Design: Overview South Water St.

Responses on financials/programs:

Responses on Design comments:

PARCEL 2, PROVIDENCE | URBANICA RESPONSE 1.19.2022

Design: Aerial South Main St.

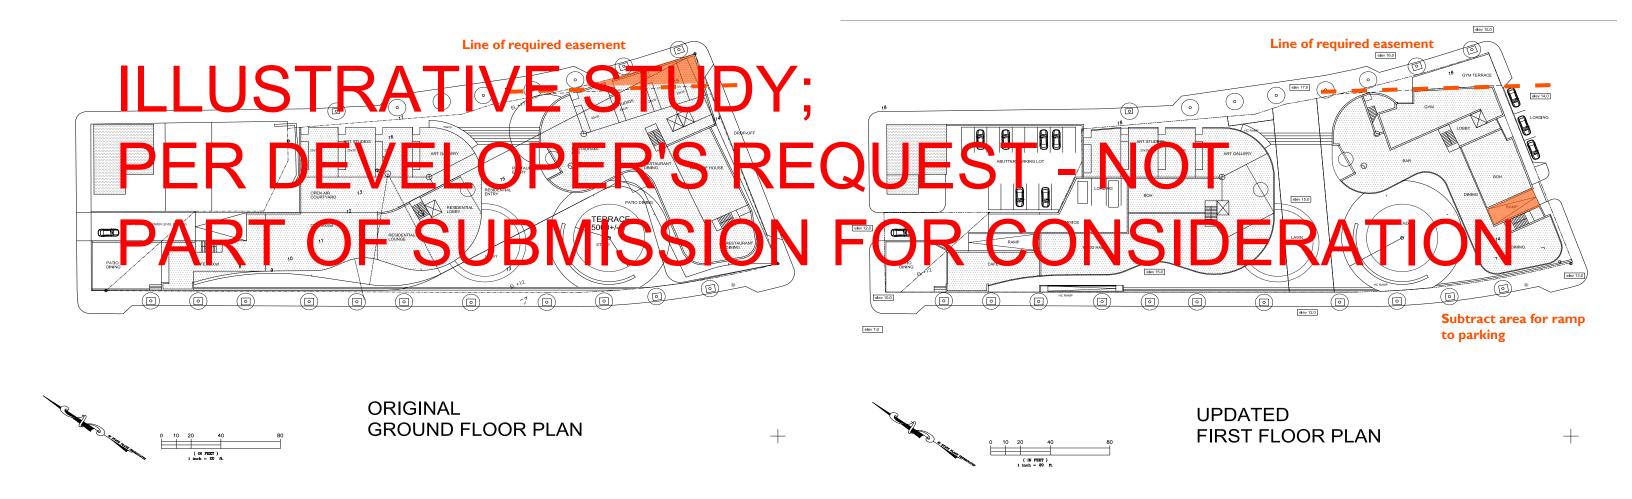
- -MASSING
- Accentuated cuts/breaks in massing to reduce apparent visual weight of the building. Indented areas are dark gray metal panel and intended to be "recessive". Upper massing is set back from lower masonry base.
- 2. -MATERIALITY
 Color/texture adjusted to approximate color/texture of existing context. Lower masonry blocks have been changed from gray to a more familiar red brick. North end building changed to masonry.

Design: Upper Floor Plans

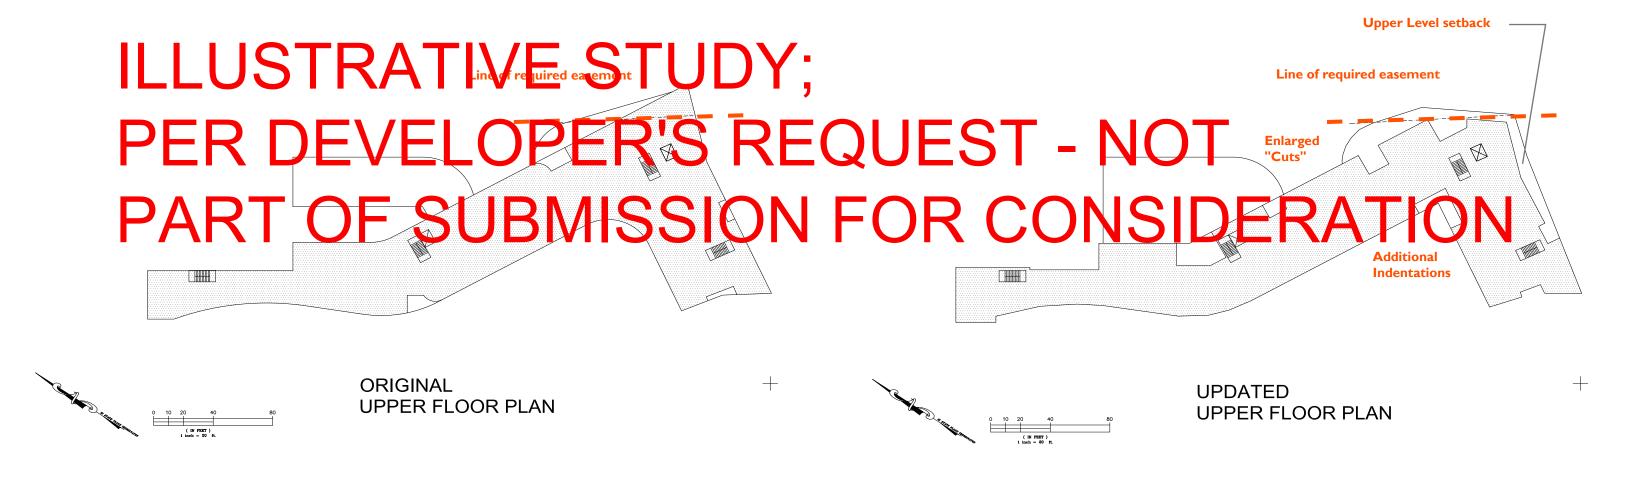
-REDUCE SCALE and DEPTH

The updated design has reduced the square footage by about 10%.

- a) The original design mistakenly ignored an easement at the corner of S Main St and Dollar St. This has been remedied on all floors.
- b) The upper floors have been set back on Dollar Street to reduce the scale of the building- especially from eye level.
- c) The number of indentations have been increased and also enlarged to further reduce the sense of scale of the building.

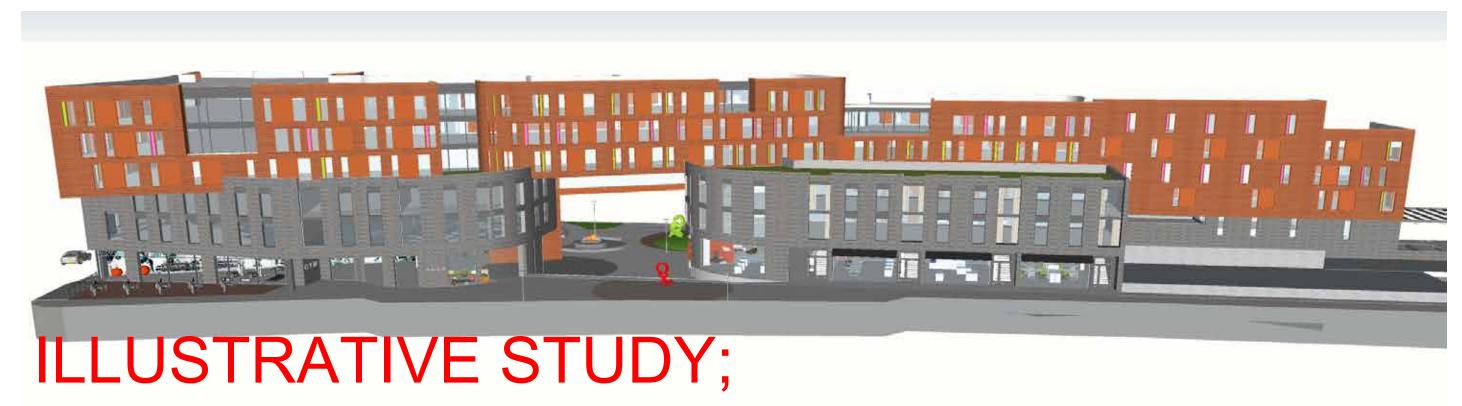
- I. Consider reducing the height of the building.
- 2. Chailer by Sking the Mass rud smaller parts DY;

119,000 GSF 101,000 GSF (reduce by approximately 15% GSF Residential)

194 units 165 units (average 500 sf)

NEW PROPOSAL- 5 stories; break into 2 separate buildings at S Water St.

NEW PROPOSAL- 5 stories; break into 2 separate buildings at S Main St.
